Date: 4-02-20 4.16.20

4824 Edgemoor Lane, Sketch Plan No. 320200020 and Preliminary Plan No. 120200070

Description

Figure 6 - Proposed Sketch Plan

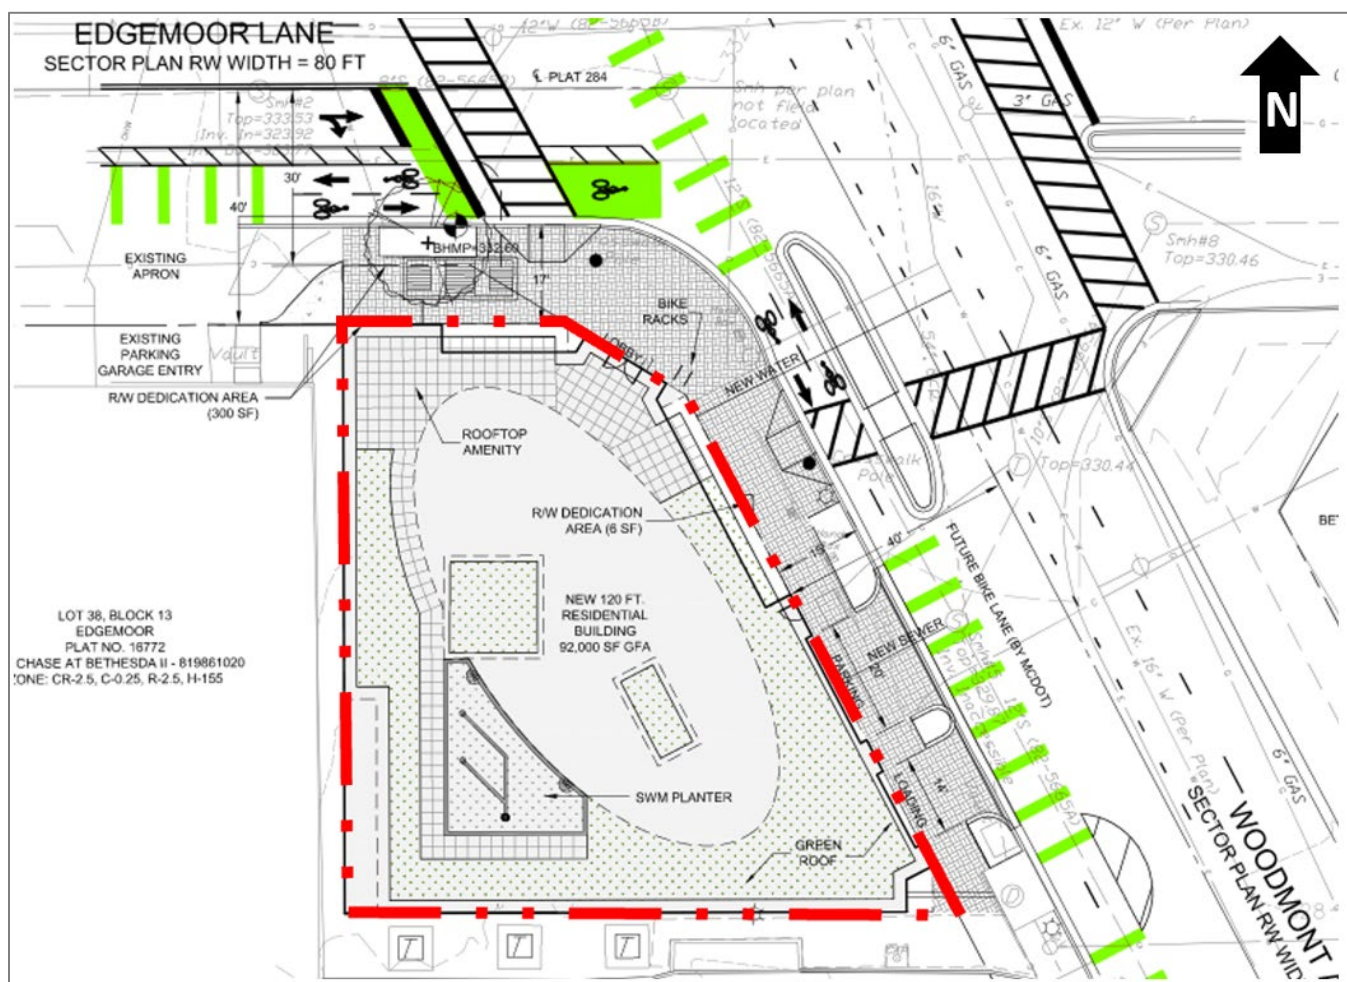
During their February 26, 2020 meeting, the Design Advisory Panel (DAP) expressed concerns about the architect's approach to addressing the Bethesda Downtown Design Guidelines' recommendations for tower separation. The design needs to mediate between the higher heights across Woodmont Avenue and the architectural character of the adjacent Chase residential building, including that building's proximity to the building proposed through the Subject Application. Of specific concern to the DAP was the treatment of the building's southern façade, which needs to achieve compatibility with the adjacent Chase Condominium building. Toward that end, the DAP recommended that the Applicant:

- explore methods to increase tower separation above the base (4 stories) to achieve a minimum separation of 30' and an average separation of 40'.

At the time of Site Plan submission, the Applicant must explore methods to increase the tower separation, along the south façade, to the existing Chase Condominium building. Above the base (i.e., four stories) the Applicant must endeavor to achieve a minimum separation of 30 feet and an average separation of 40 feet, consistent with the DAP's February 26, 2020 meeting minutes.

Figure 11 - Pedestrian and Vehicular Circulation

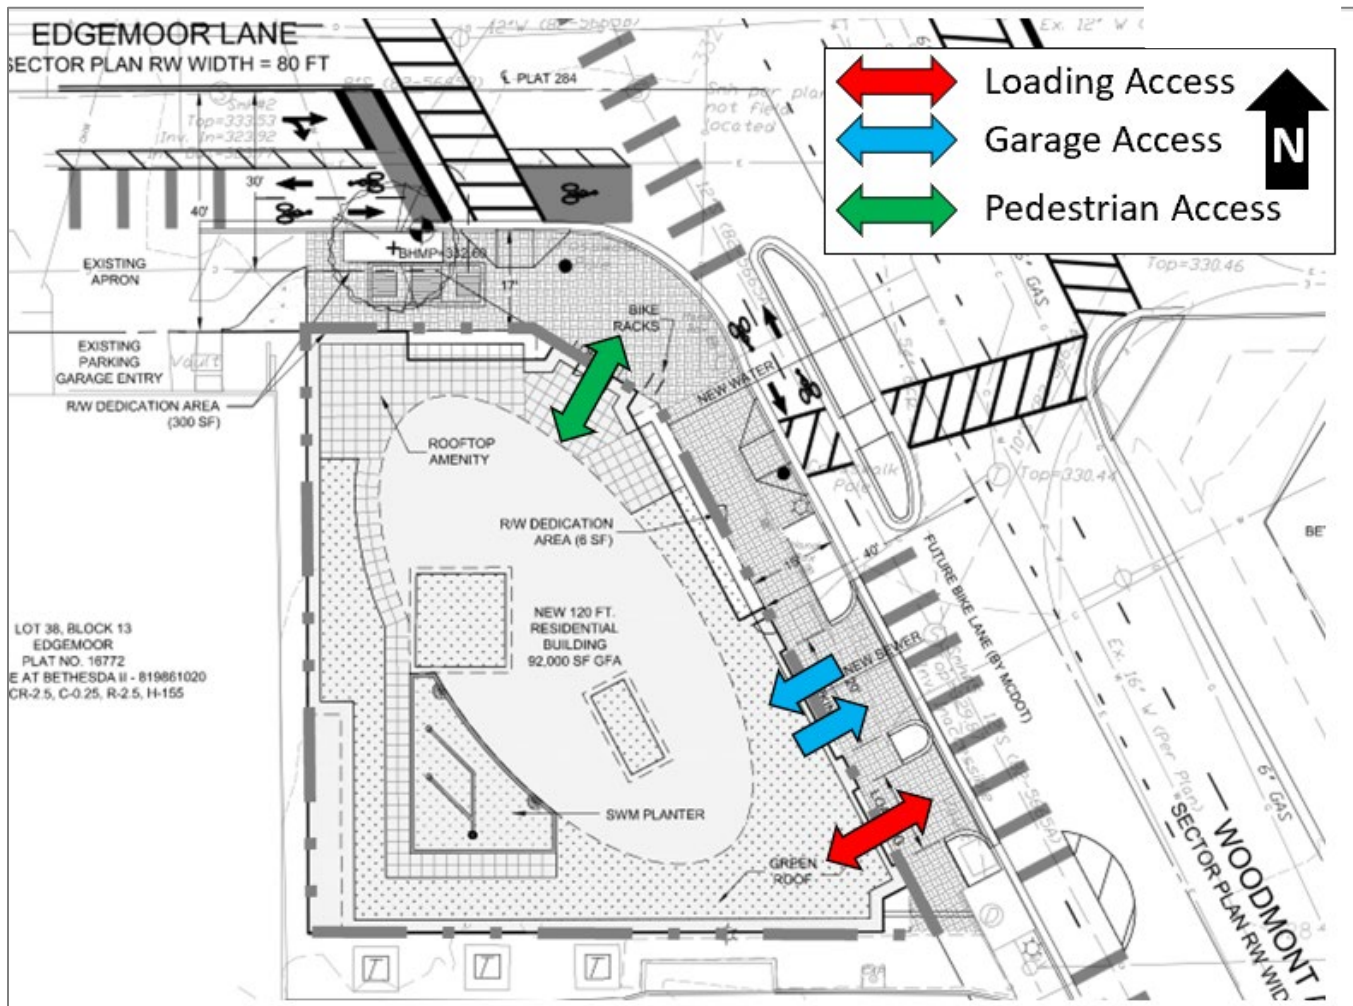
- The Project is located too close to the adjacent streets and will endanger pedestrians by creating blind spots where vehicles exit the garage.

Staff Response: The proposed building will be built to the property line and the garage/ loading entrance will be located along the back of the sidewalk without pulling back the building around the garage entrance. This design is consistent with other urban projects and will have elements that contribute to a safe pedestrian environment. Some of these elements may include traffic control signs within the garage (i.e. "STOP," "Pedestrian Crossing," etc.) and must include the Bethesda Streetscape with a minimum sidewalk width of 8 feet. The Bethesda sidewalk bricks will serve as a visual queue to drivers that the entry/ exit crosses a main pedestrian path and is not a suburban parking lot drive aisle.
